**DEADMAN'S BASIN
TERMINAL OUTLET REPLACEMENT PROJECT
WHEATLAND COUNTY, MONTANA
ADDENDUM #1**

April 24, 2009

GRAIN SIZE DISTRIBUTION TEST REPORT

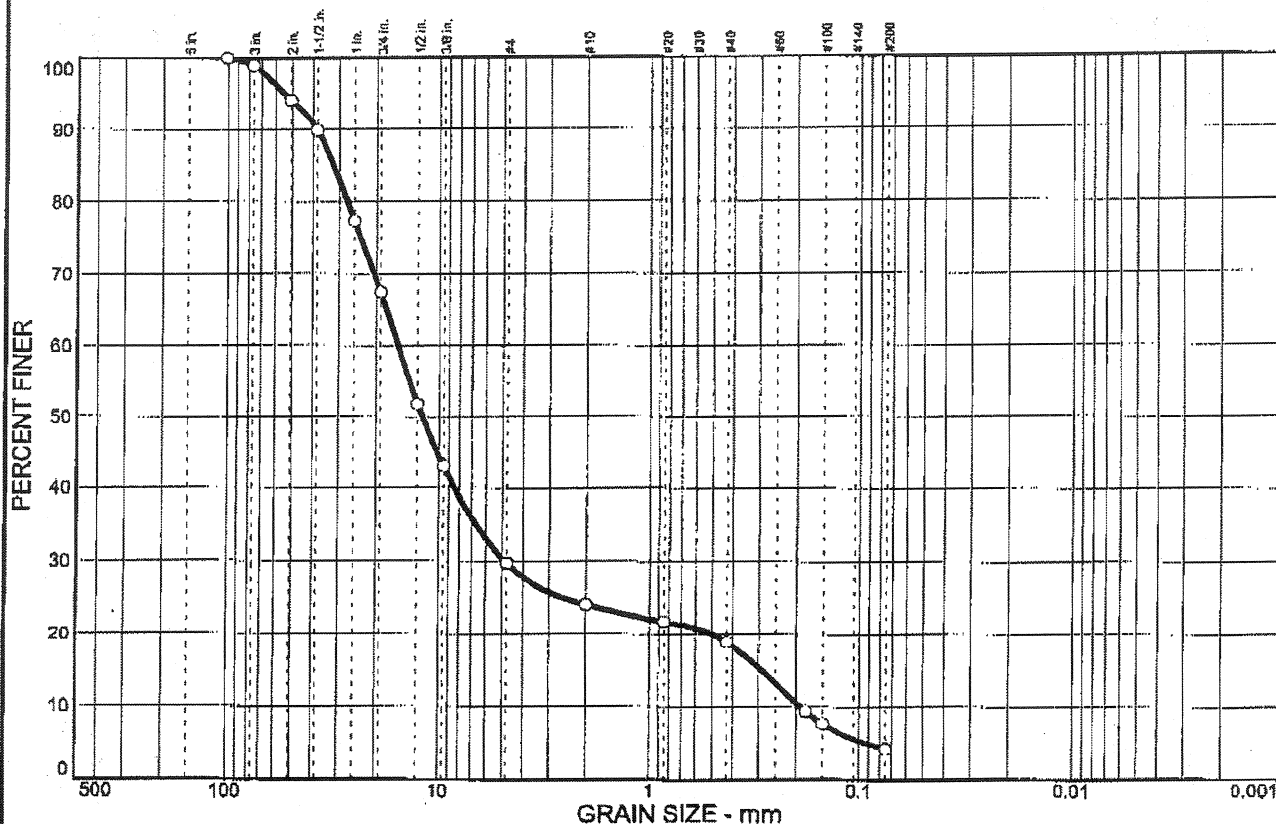
Answer: There is a gravel pit near the site that has been used on previous projects associated with Deadman's Basin Dam and canals. Attached is a 2005 memo, map and sieve analysis of the pit. As the gradation of the drain gravel is critical, there is a good chance that materials in the pit will need to be processed to meet project specifications for drain gravel.

MOISTURE-DENSITY RELATIONSHIP TEST

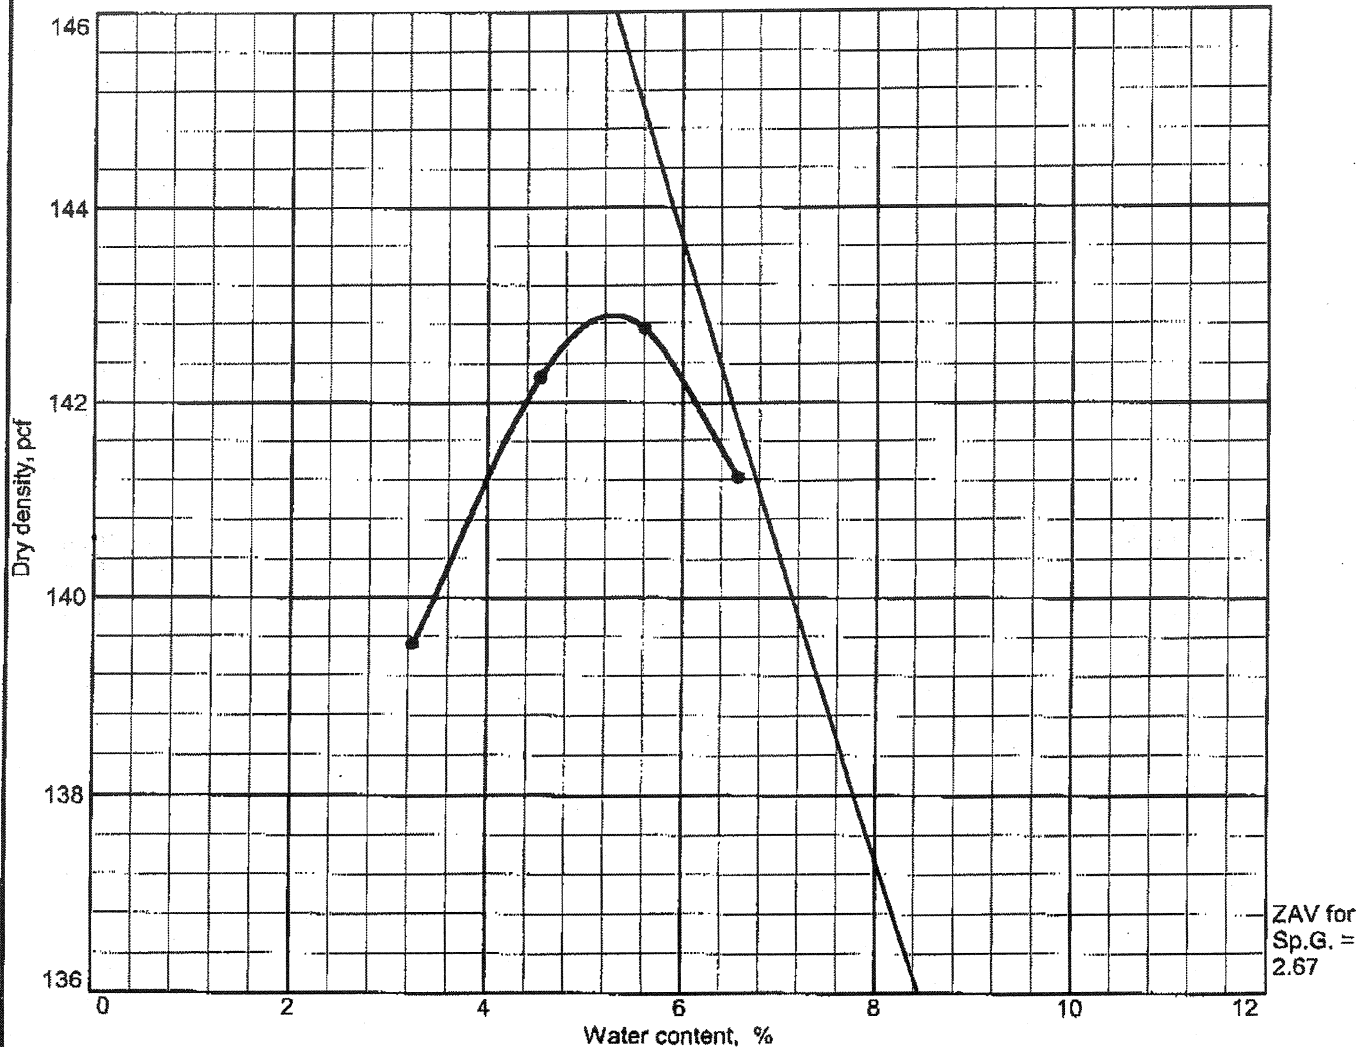
Attached is a portion of a memo written in 2005 that contains information about the gravel pit on DNRC property located near the project site. The memo, map and sieve analysis are presented for informational purposes only as the gravel pit has been used since the memo was prepared. Bidders will need to verify both quantities and available gradation but should know that this gravel source can be used if the material can be processed to meet drain gravel specifications.
